DEVELOPMENT NO.:	21039035
APPLICANT:	Alan Cooper
ADDRESS:	43A MARLBOROUGH ST BRIGHTON SA 5048
NATURE OF DEVELOPMENT:	Three storey detached dwelling
ZONING INFORMATION:	Zones: <ul style="list-style-type: none"> • General Neighbourhood Overlays: <ul style="list-style-type: none"> • Airport Building Heights (Regulated) • Affordable Housing • Prescribed Wells Area • Regulated and Significant Tree • Stormwater Management • Urban Tree Canopy
LODGEMENT DATE:	20 Dec 2021
RELEVANT AUTHORITY:	Assessment panel
CATEGORY OF DEVELOPMENT:	Code Assessed - Performance Assessed
NOTIFICATION:	Yes
RECOMMENDING OFFICER:	Dean Spasic Development Officer - Planning,

Compromise Plans

Wall Heights

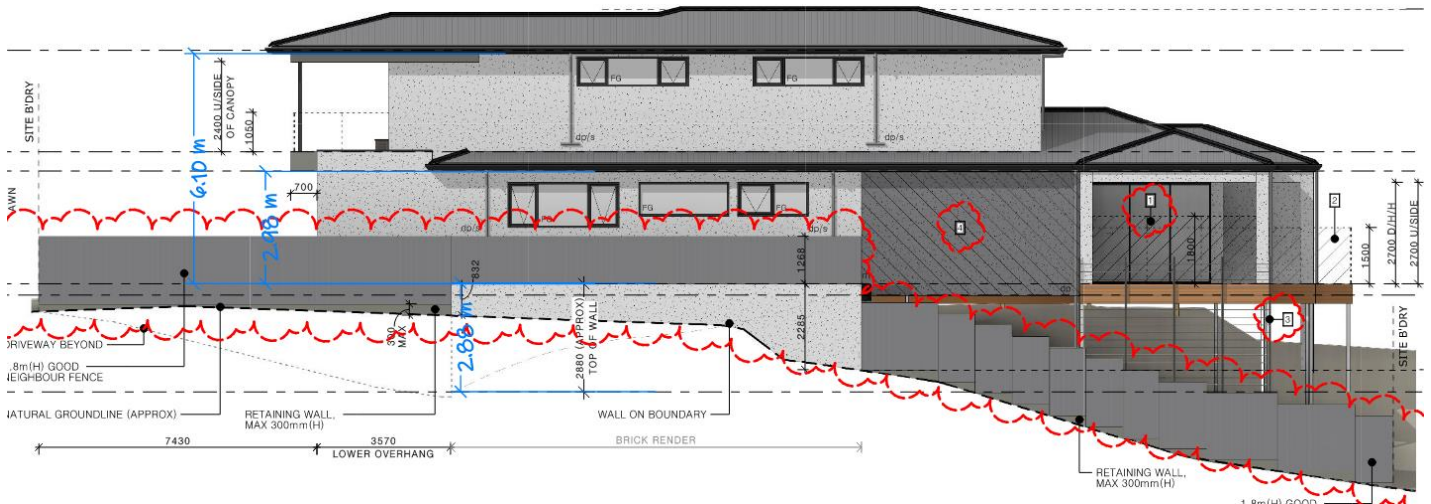
Where walls are not on the boundary, the wall heights, relative to the footings, satisfy DTS 4.1 (whereby a 'wall height' is defined as *the height of a wall measured from the top of its footing*).

The boundary wall is 2.88 metres in height above the top of the footing, as prescribed in DTS 7.1 and comprises a length of 11 metres, which satisfies DTS 7.1 (maximum height of 3 metres and maximum length of 11 metres). Furthermore, the maximum boundary wall height above natural ground level is 2.3 metres, which is the result of the wall being mostly below natural ground level.

The ground level wall is 2.98 metres above the footing, and the upper level wall is 6.1 metres above the footing, therefore satisfying DTS 4.1, which allows a maximum height of 3 and 7 metres.

The boundary wall is 2.88 metres in height, relative to the footing.

Refer to highlighted dimensions in blue:

Western Side Boundary Setback

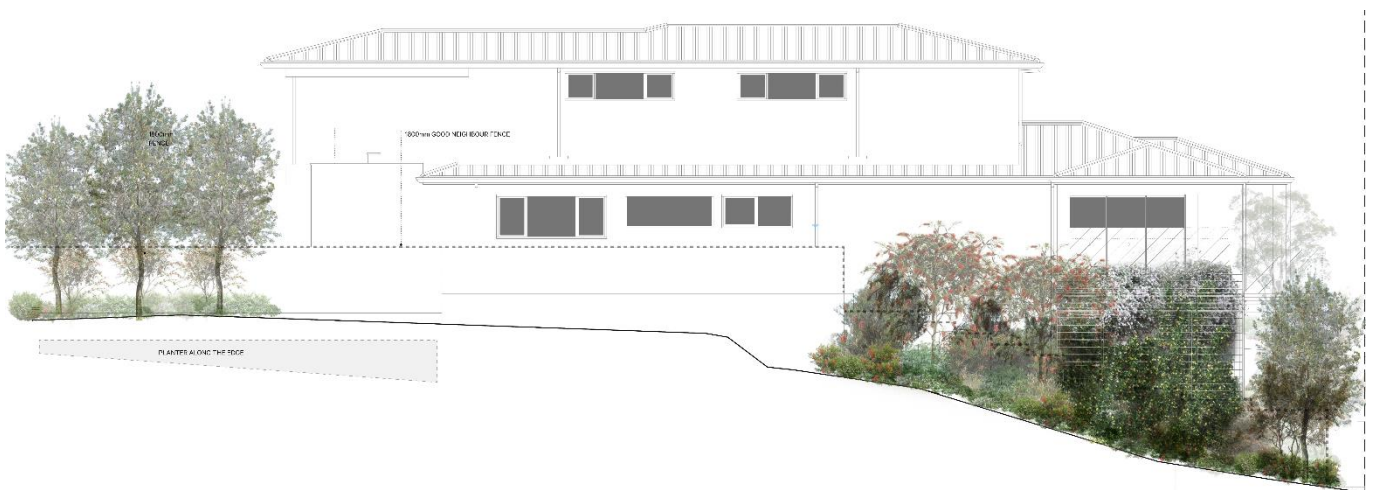
The increase in the ground level western side boundary setback by 360mm along with increased landscaping, including an emphasis on vertical plantings, is also considered a positive adjustment and directly addresses visual mass when viewed from adjoining allotments.

As noted, privacy screening has also been increased along the western elevation of the rear balcony/terrace, which contributes to improving privacy.
